Addendum #1

Project Name: Indiana State University – Dreiser Hall Renovation

Project #: 19052

Date: June 12, 2020

1 Floor Plan
3rd Floor Plan
A1.03 1/8" = 1'-0"

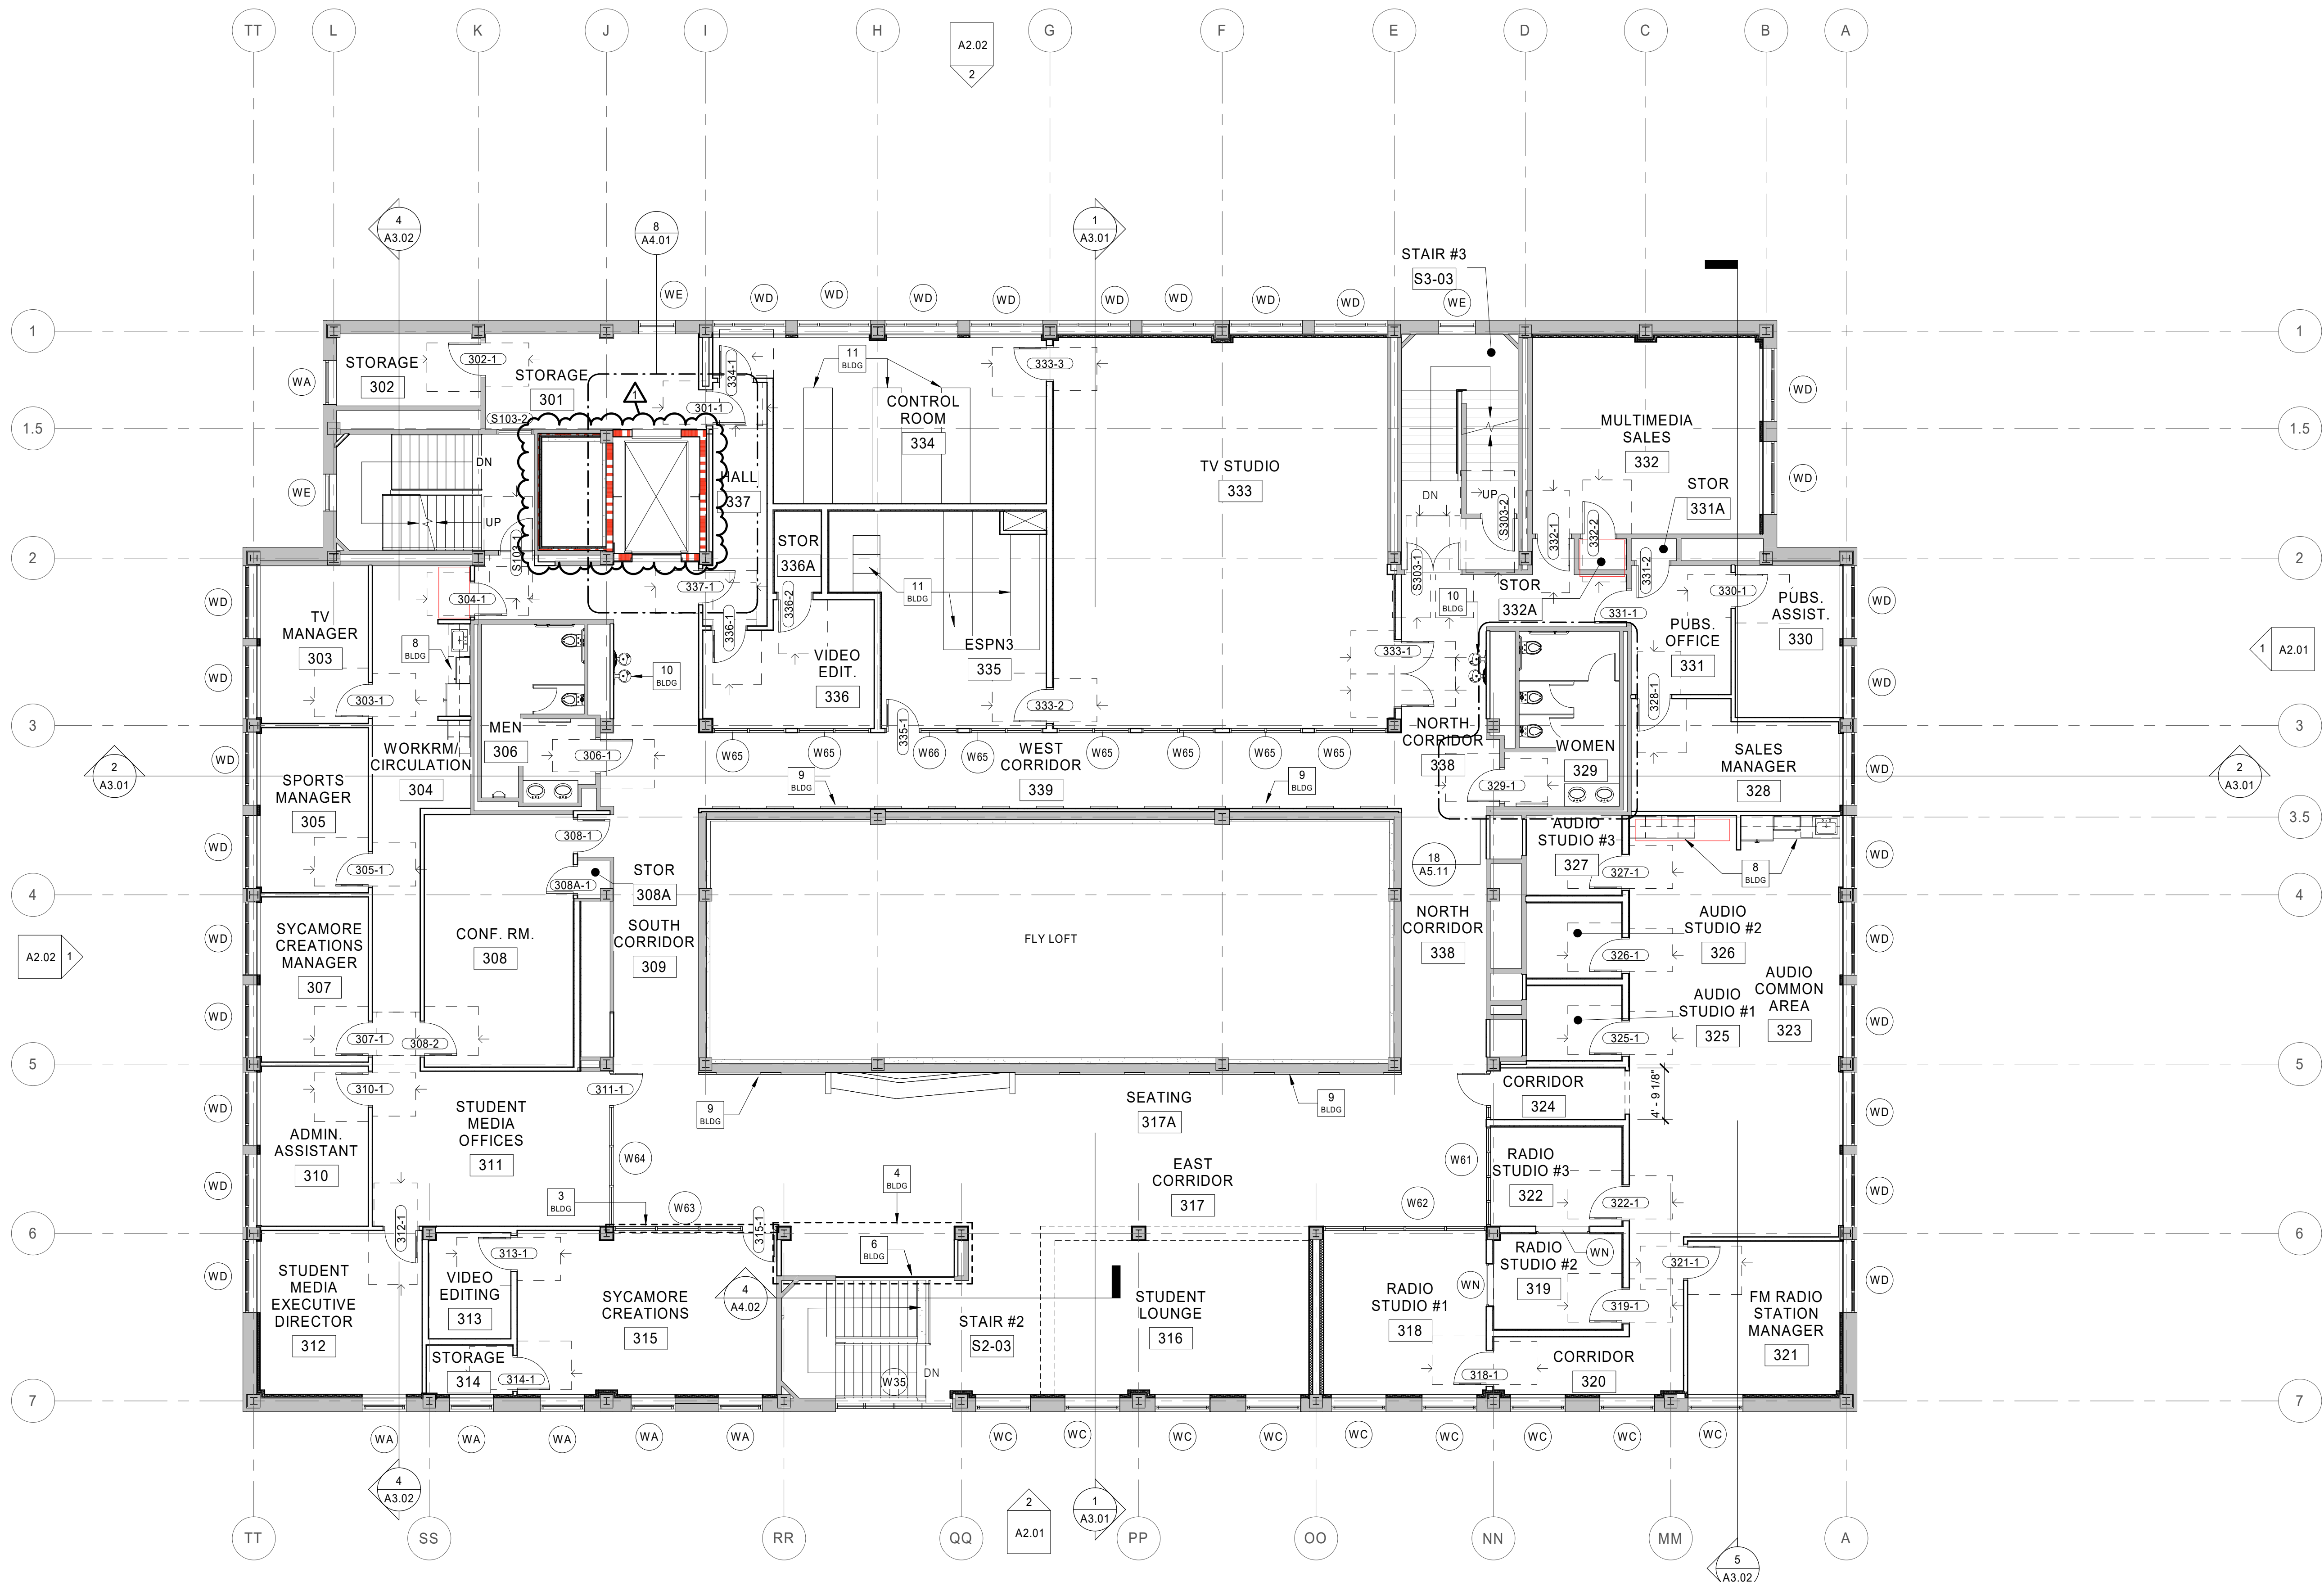
16. Sheet A1.03 – Third Floor Plan
- A. Reissue sheet – see clouds

- B. Add rated wall indicators.

1 Floor Plan
Control Room - New
A1.04 1/8" = 1'-0"

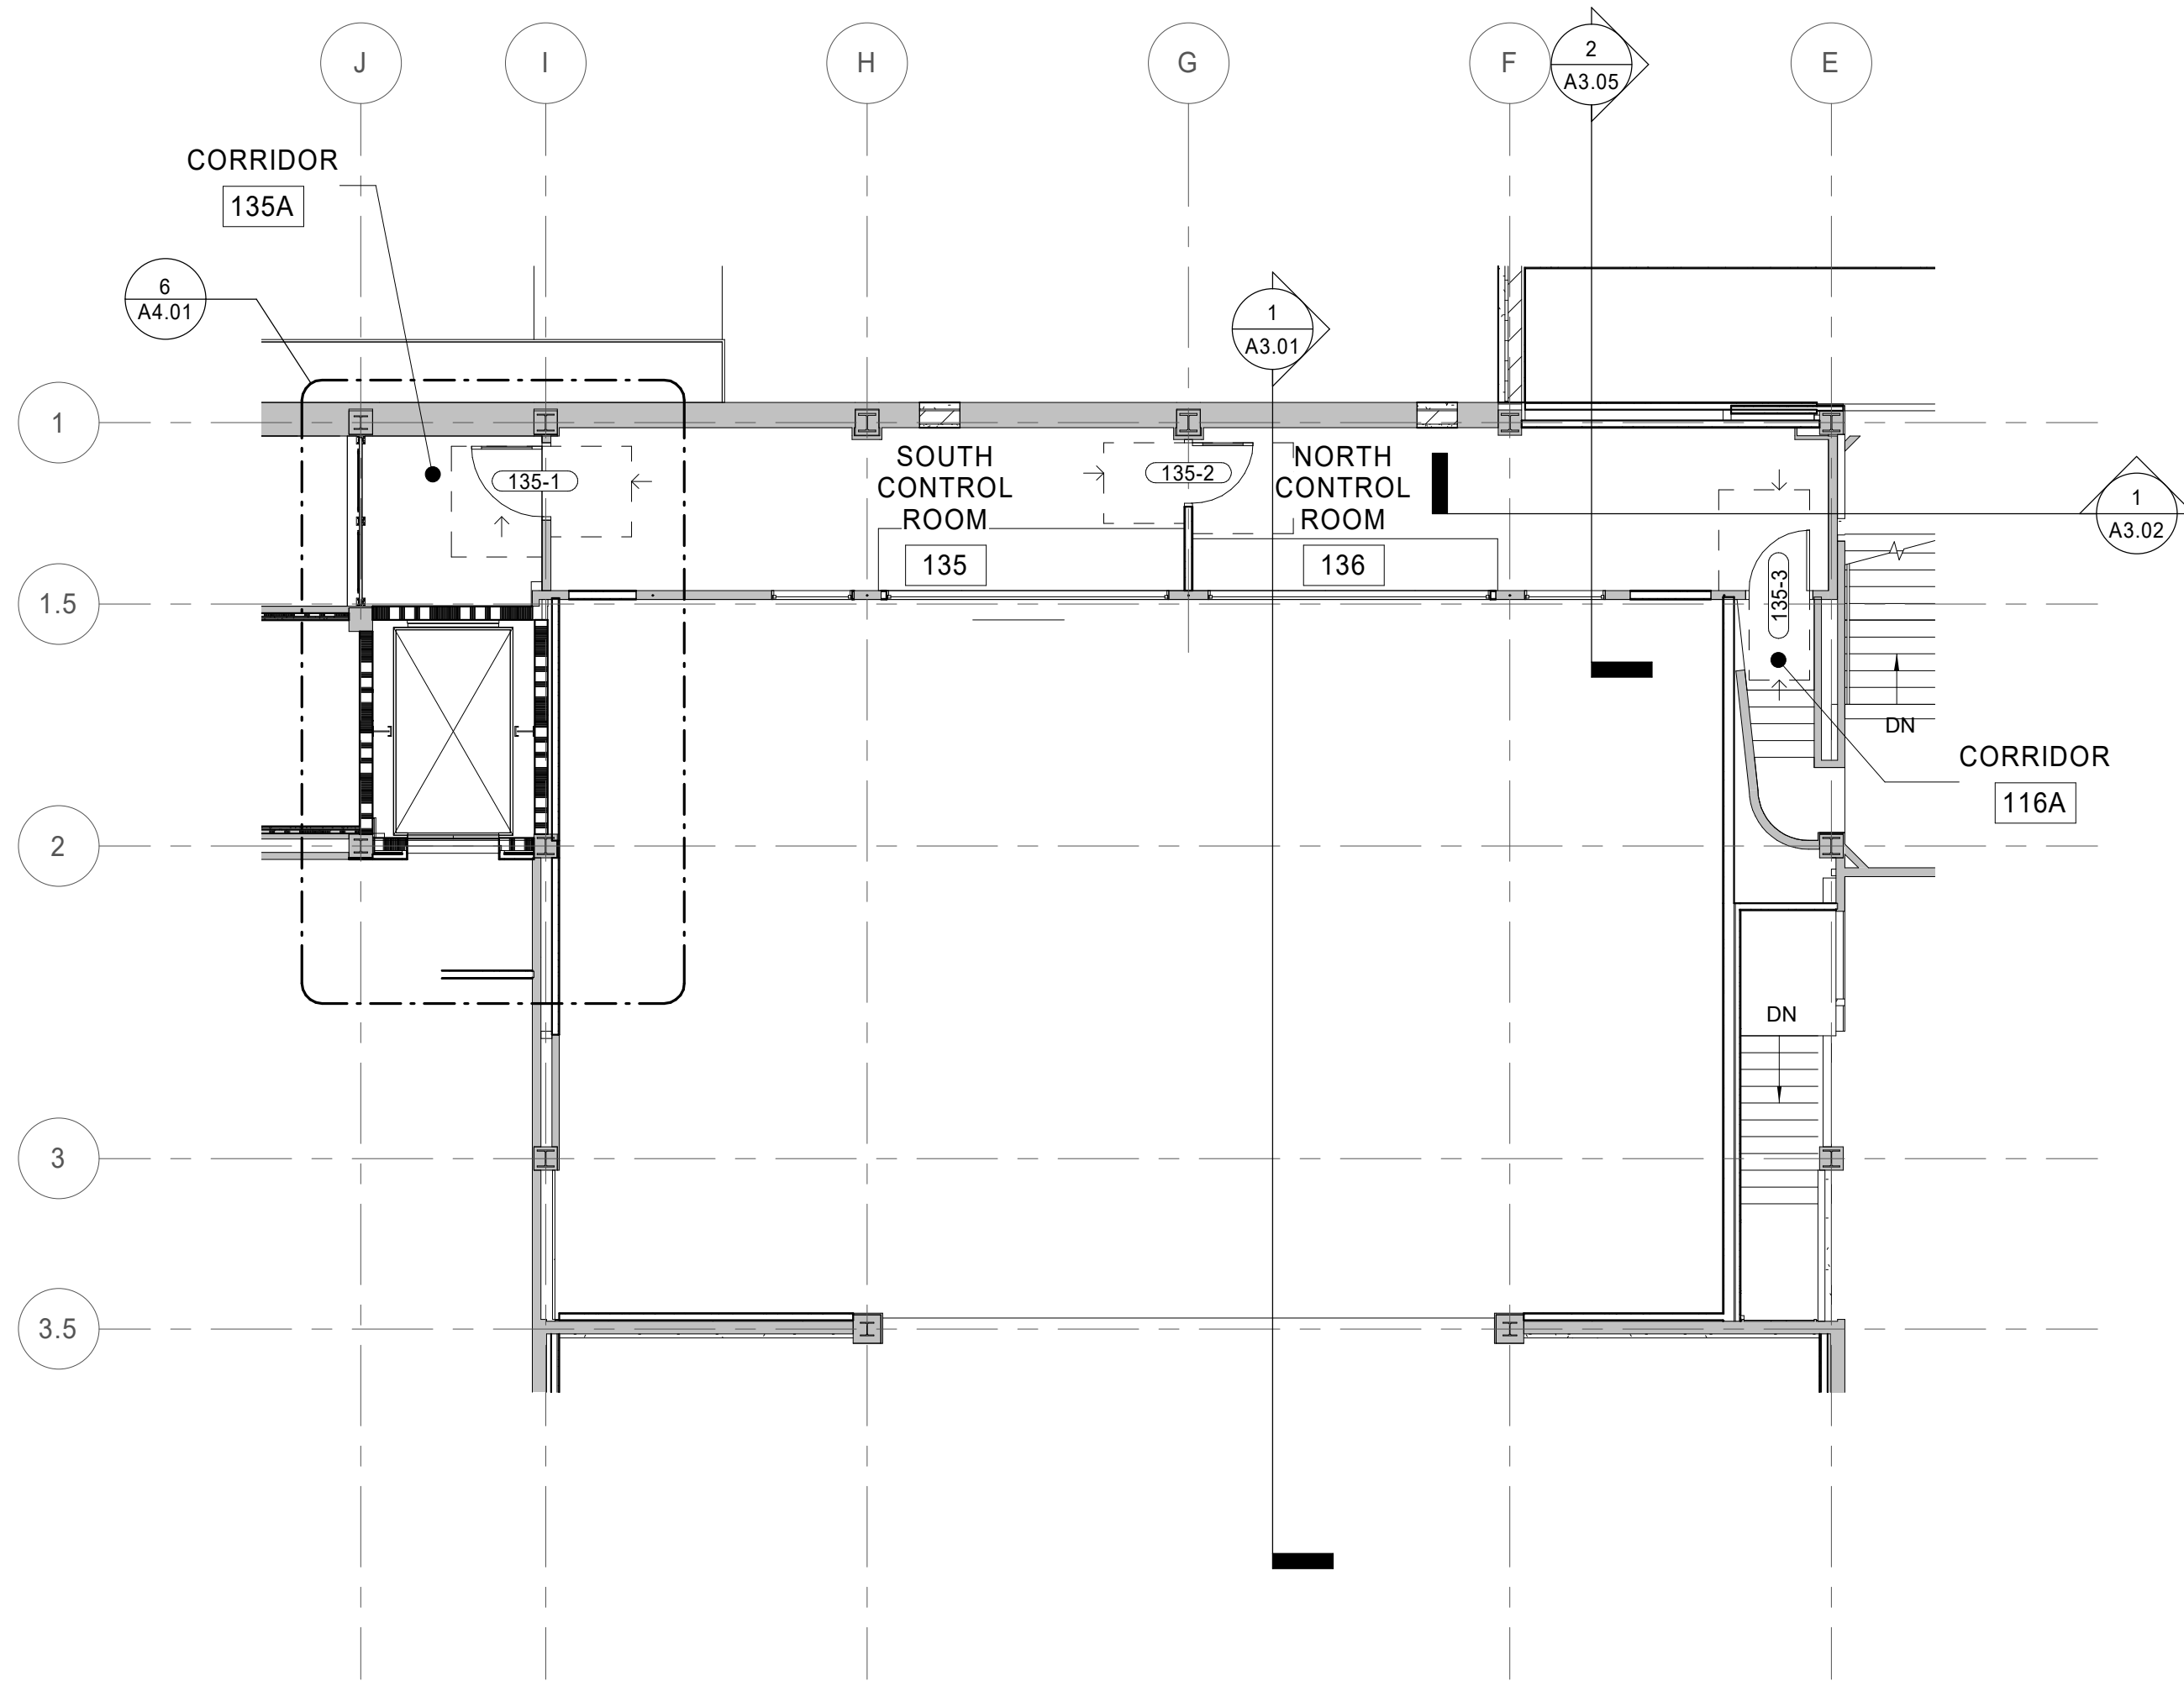
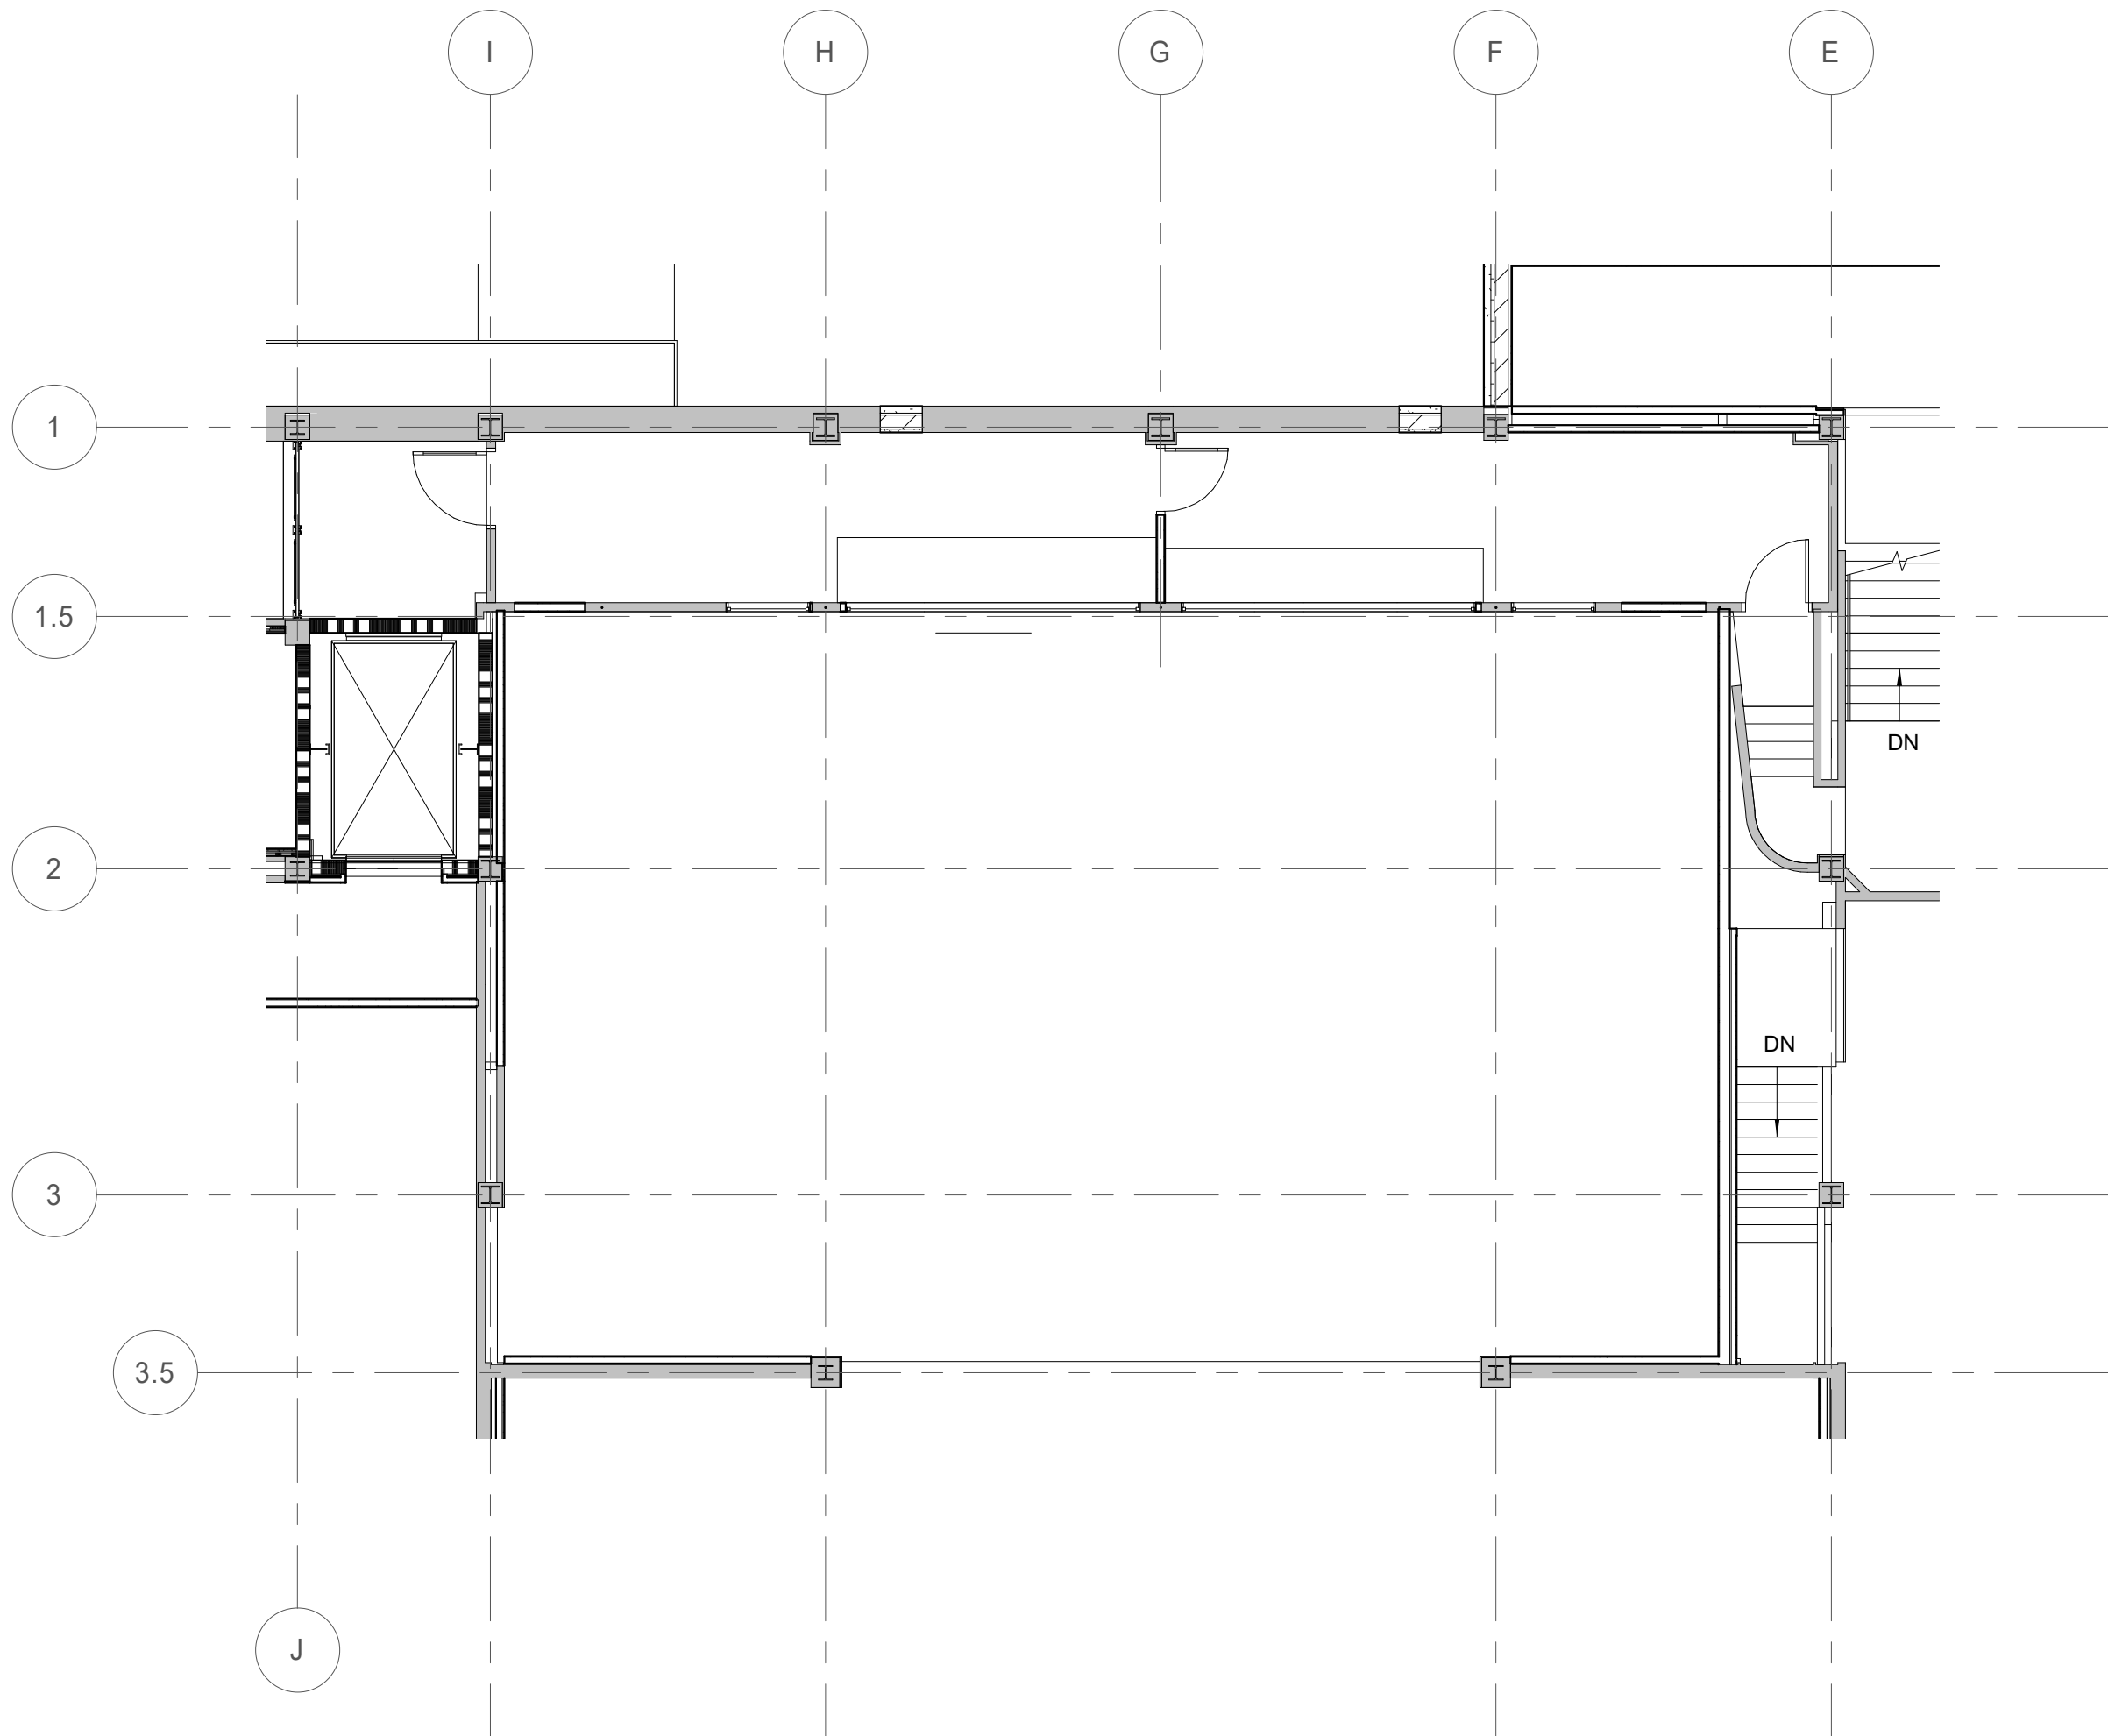
20. A1.04 – Control Room Plans

- A. Reissue sheet – see clouds
- B. Removed Existing Plan
